**City of Phoenix
Office of the City Engineer
Design and Construction Procurement**

**LIFT STATION 76 PHASE II EXPANSION
WS90400067**

ADDENDUM NO. 3

ISSUE DATE: APRIL 25, 2024

M04 SHEET 15 OF 40

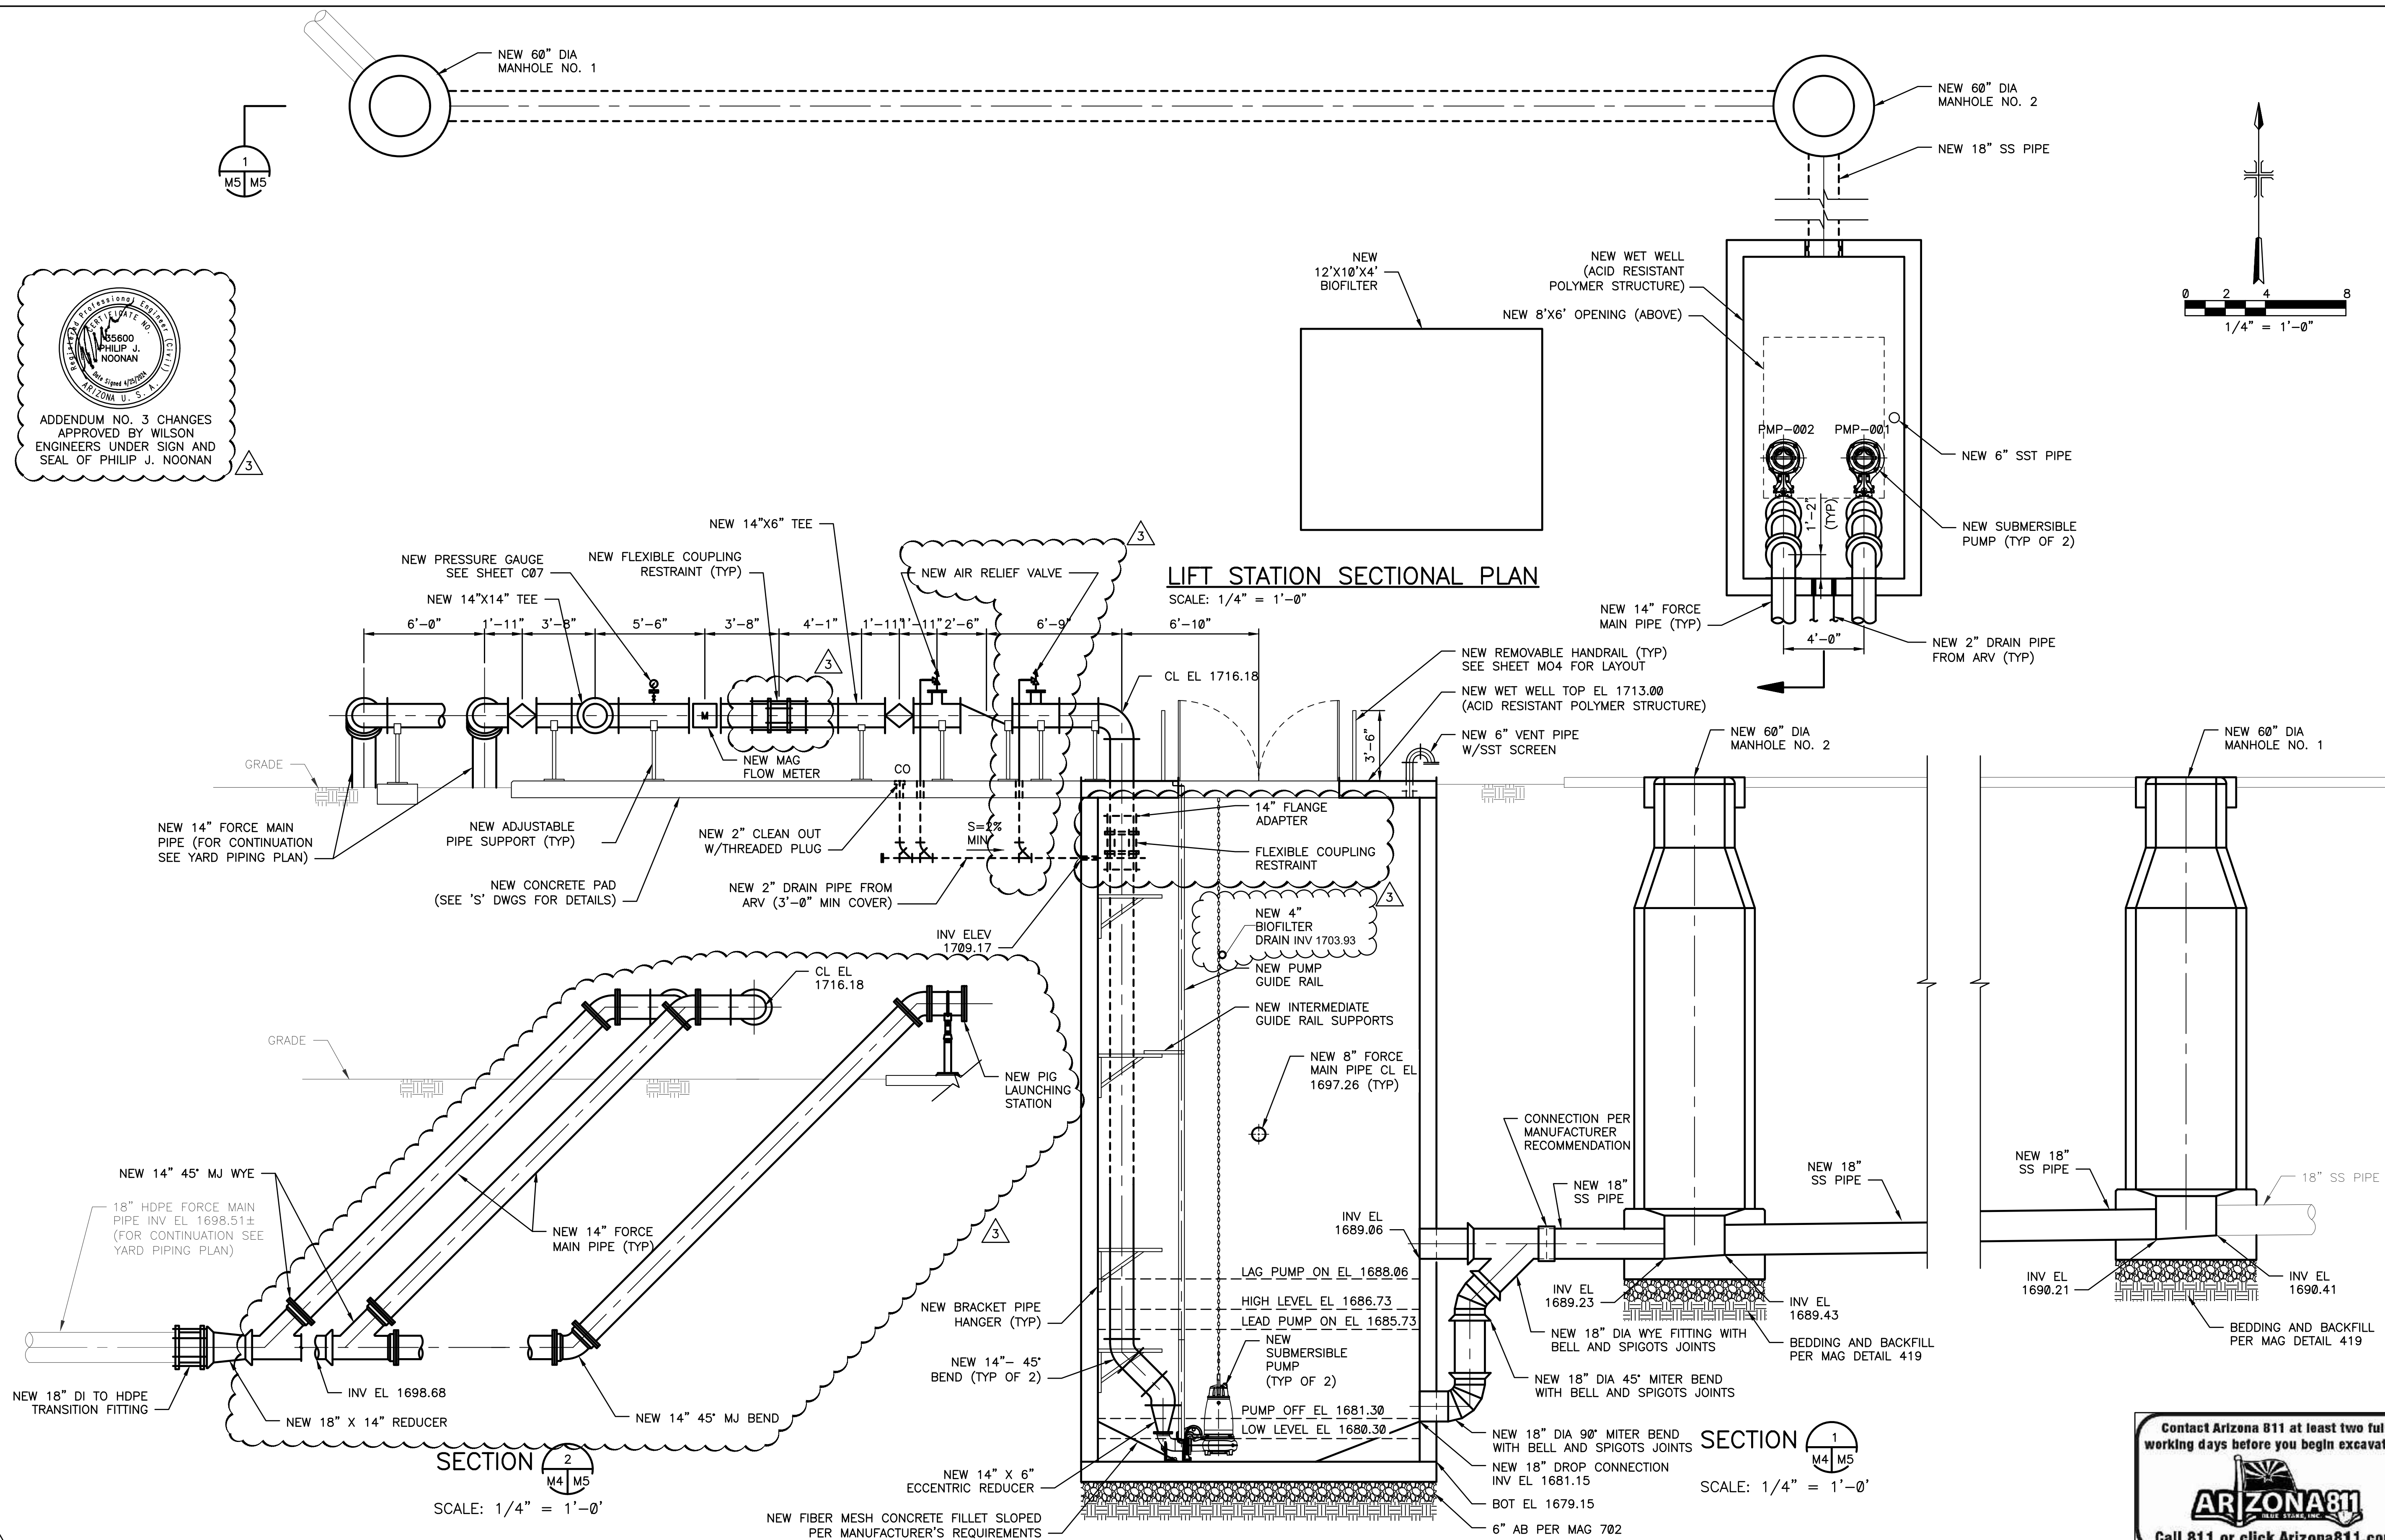
26. **PROJECT TECHNICAL DRAWINGS:** **DELETE** Sheet M04 in it's entirety and **REPLACE** with attached revised Sheet M04, modifications are clouded.
27. **PROJECT TECHNICAL DRAWINGS:** **DELETE** Sheet M05 in it's entirety and **REPLACE** with attached Revised Sheet M05, modifications are clouded.

COPYRIGHT © 2007-JANUARY
CITY PROJECT NO. WS90400067-4
DATE: MAY 2023
M06 SHEET 17 OF 40
CAD FILE: 04276.05_M06

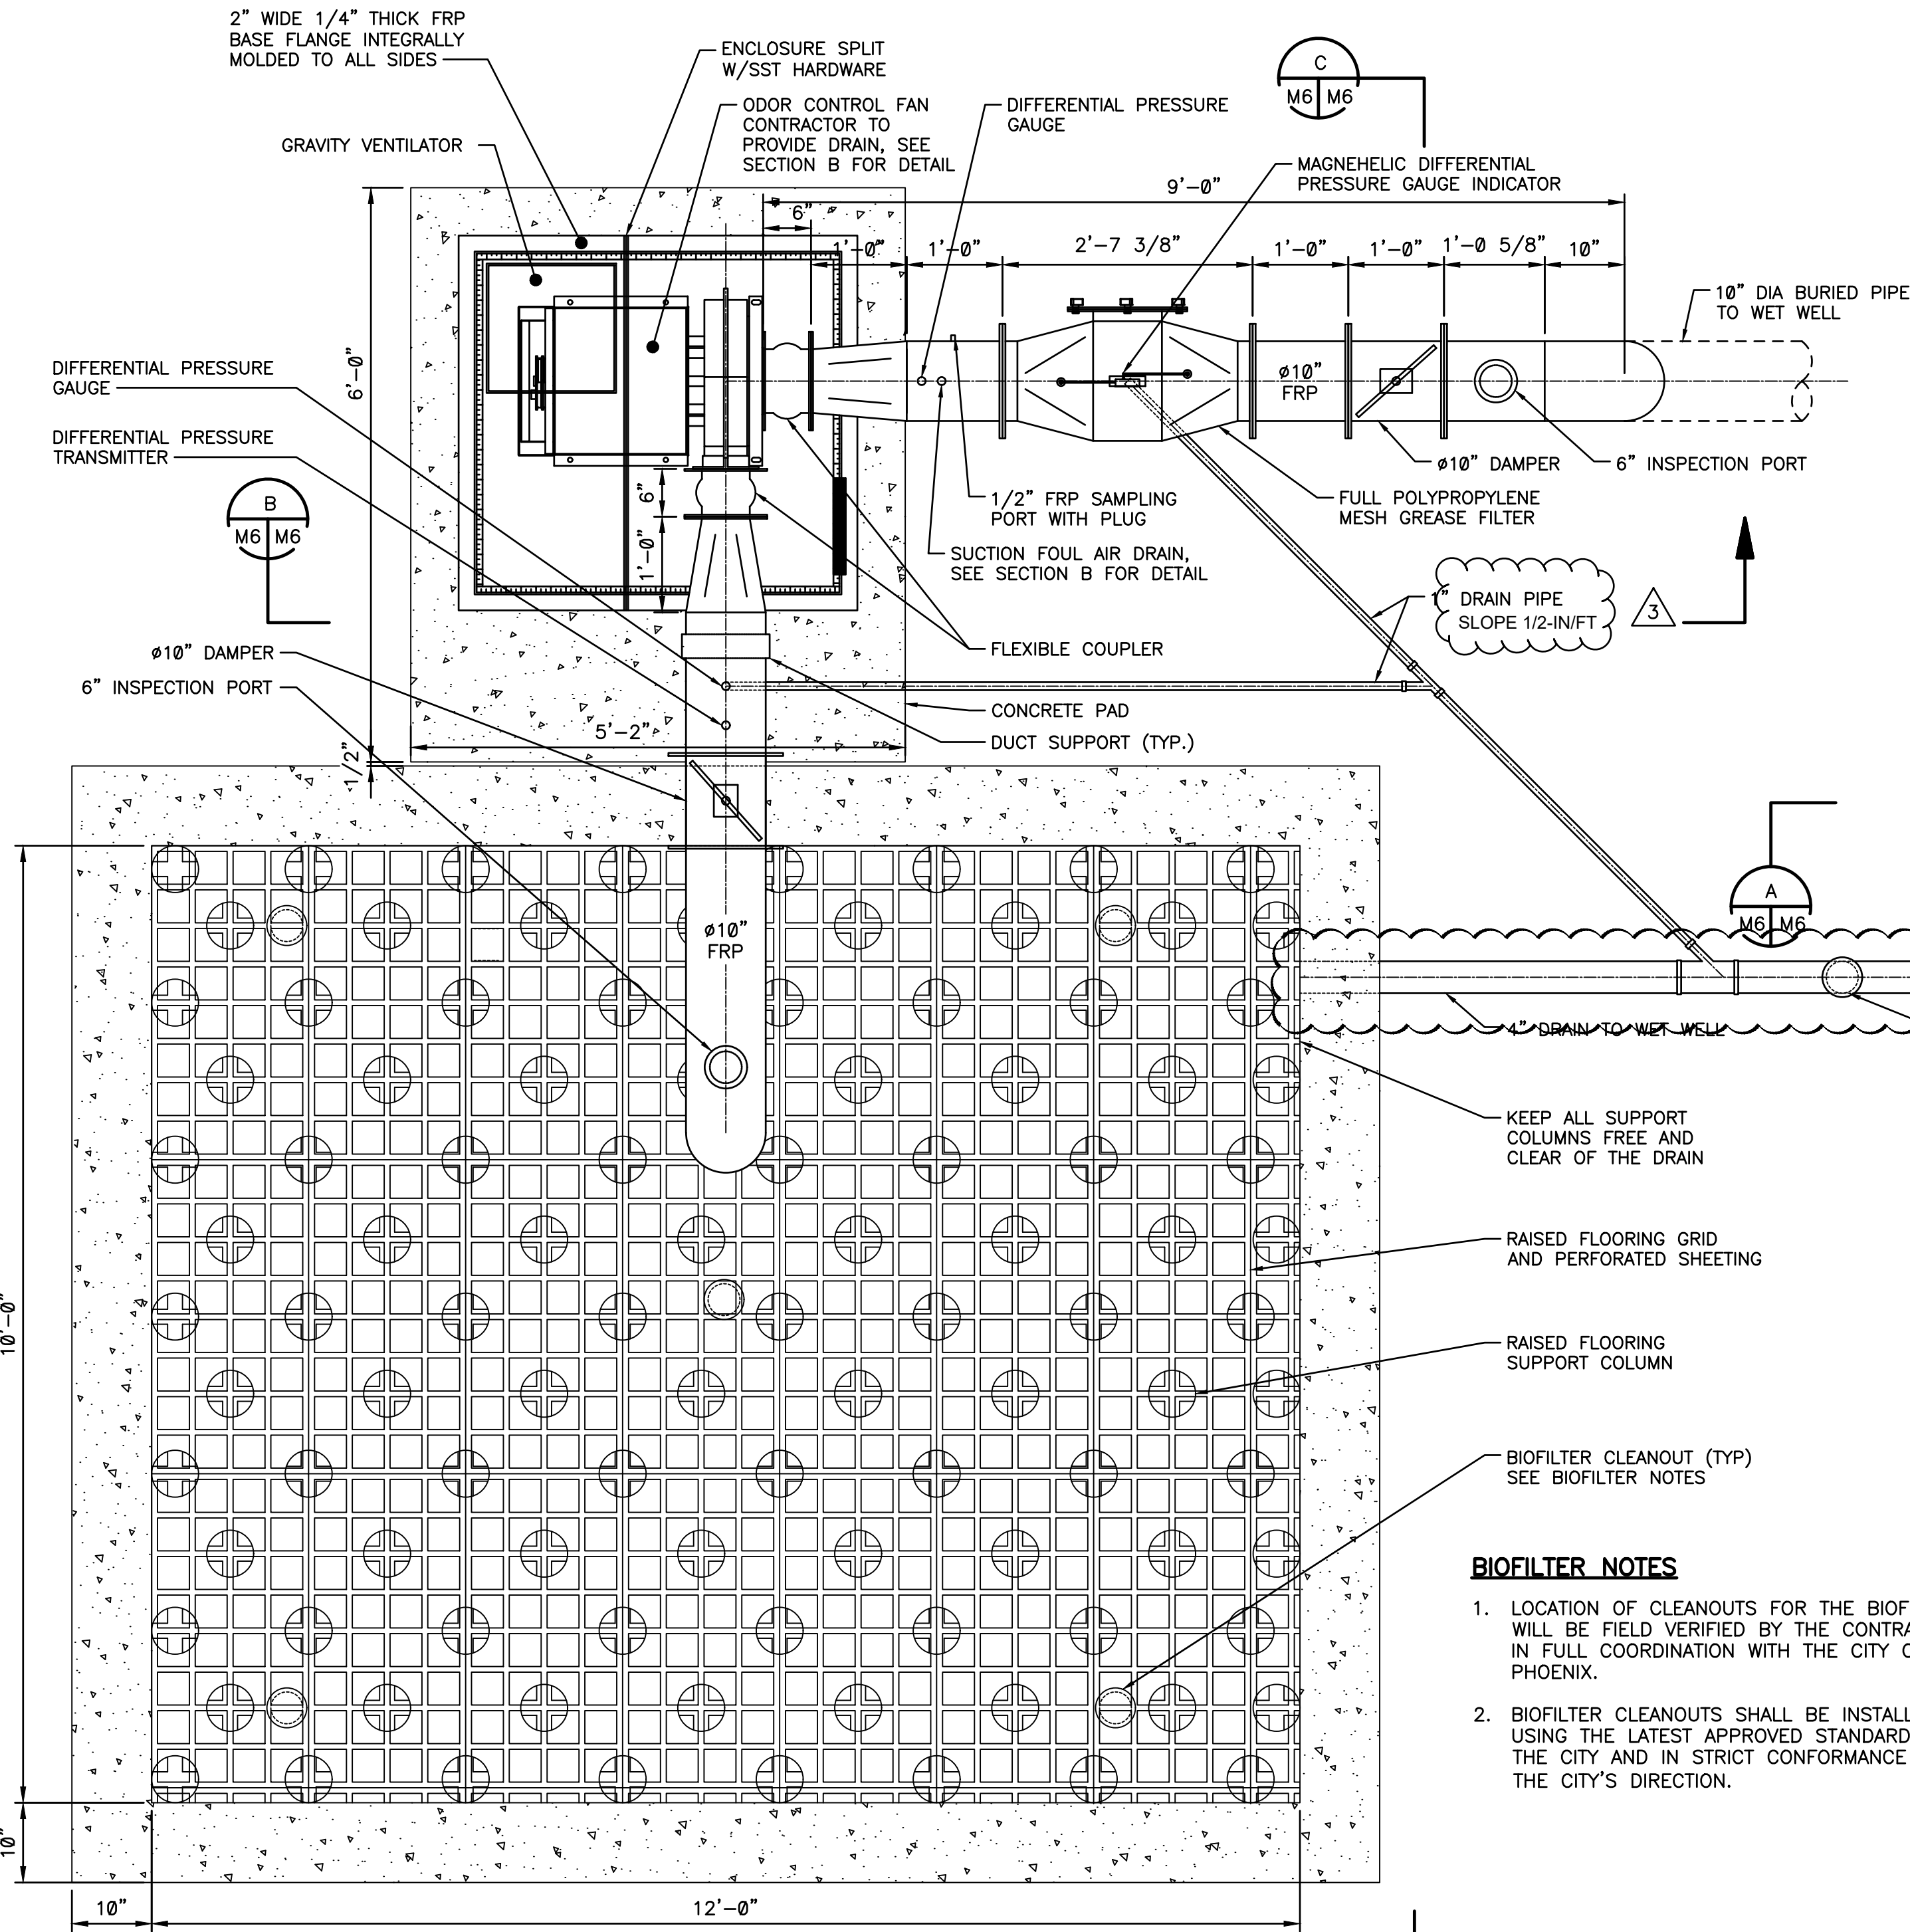
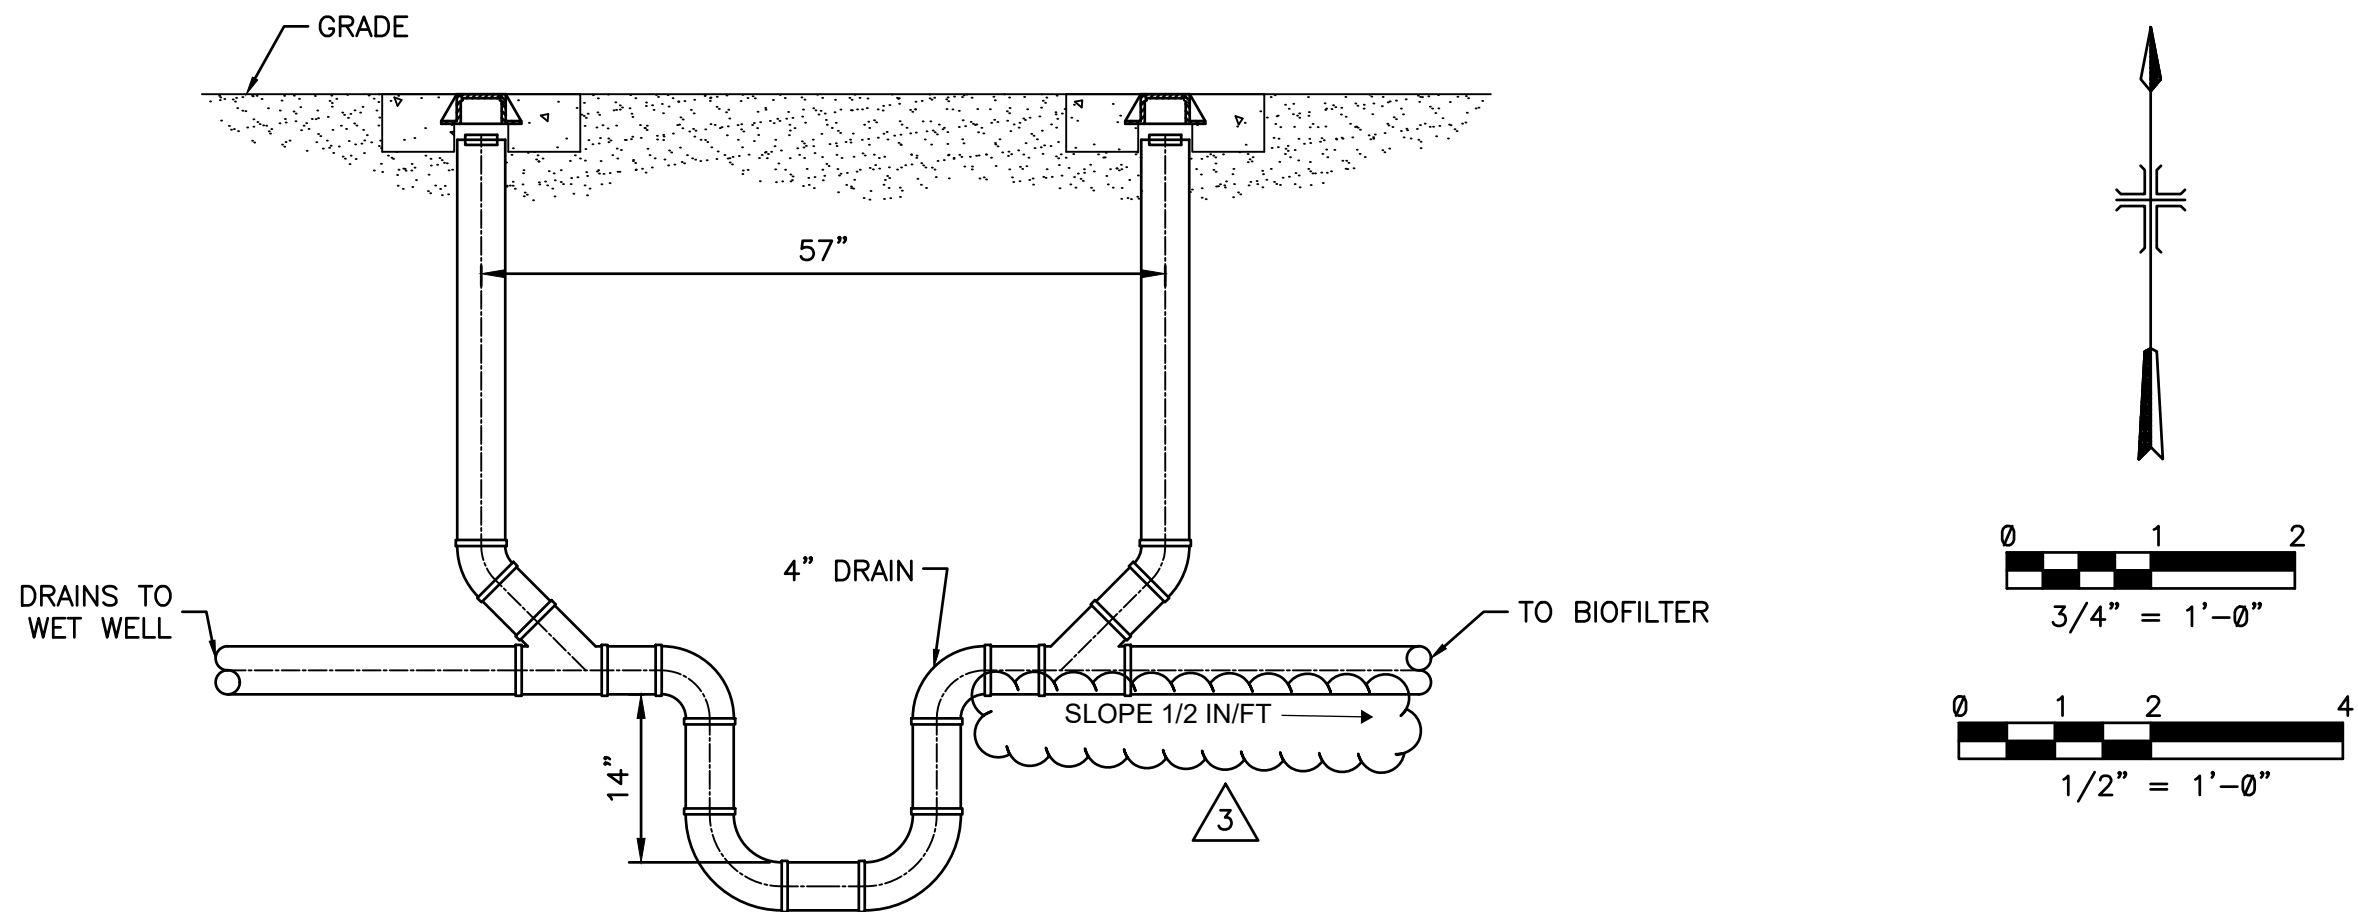
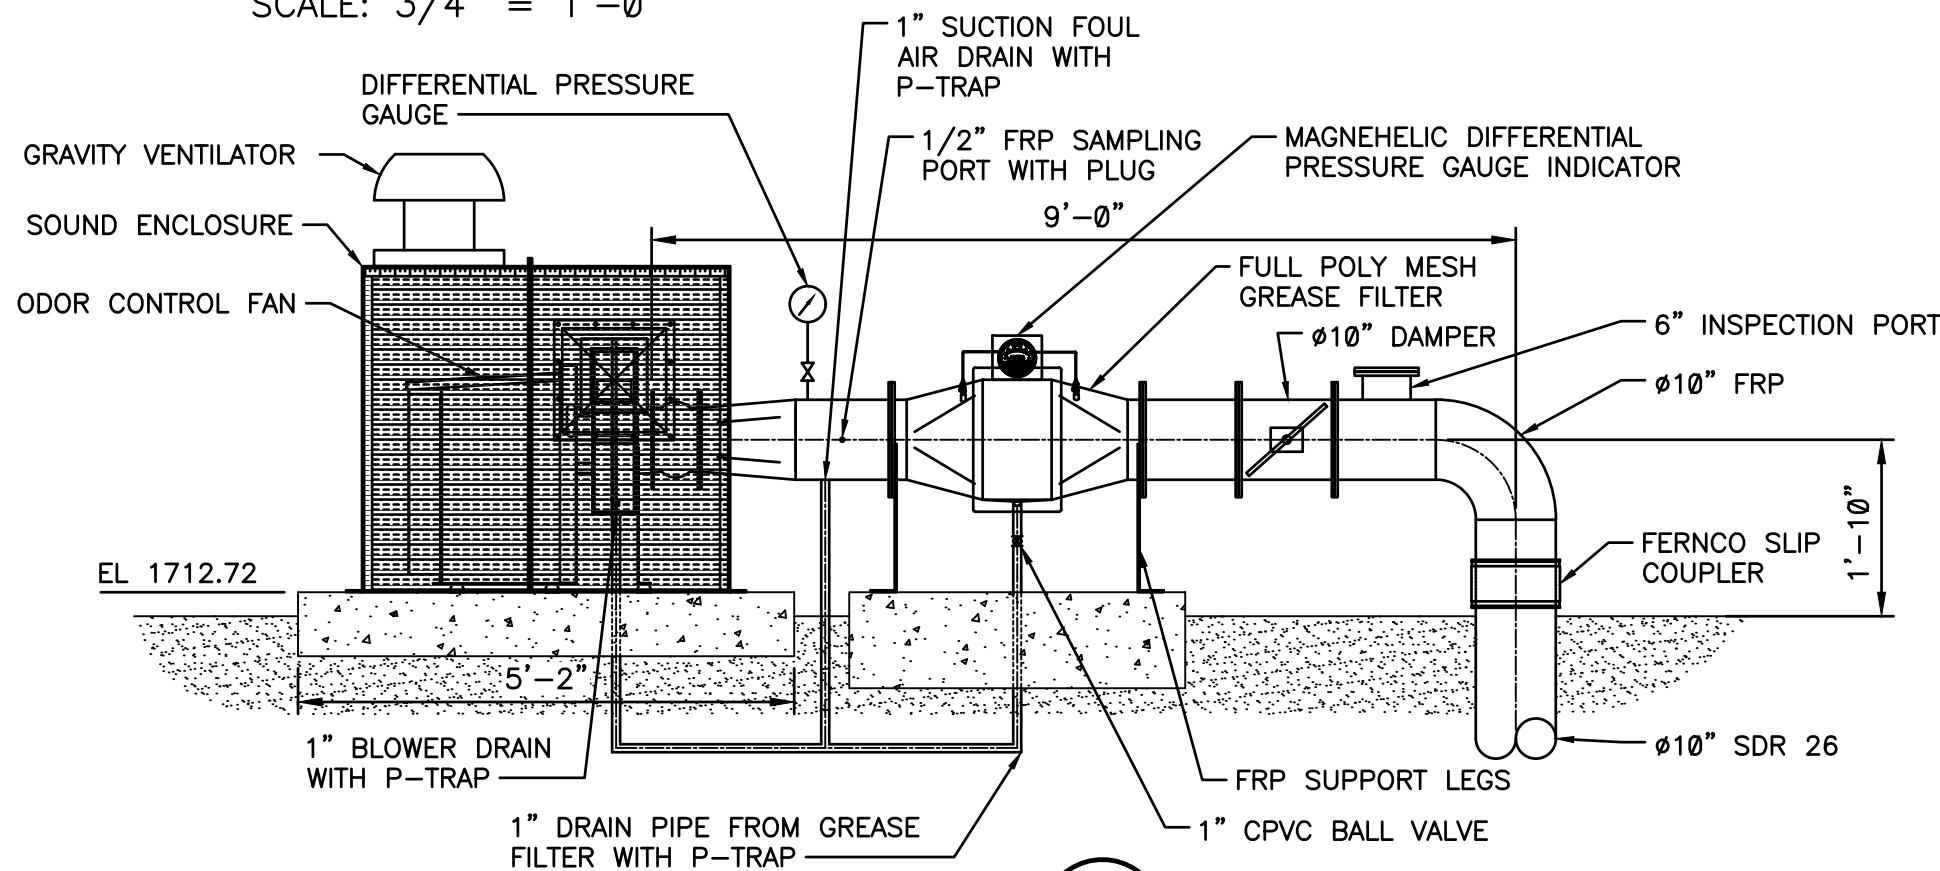
28. **PROJECT TECHNICAL DRAWINGS:** **DELETE** Sheet M06 in it's entirety and **REPLACE** with attached Revised Sheet M06, modifications are clouded.
29. **PROJECT TECHNICAL DRAWINGS:** **DELETE** Sheet M09 in it's entirety and **REPLACE** with attached Revised Sheet M09, modifications are clouded.
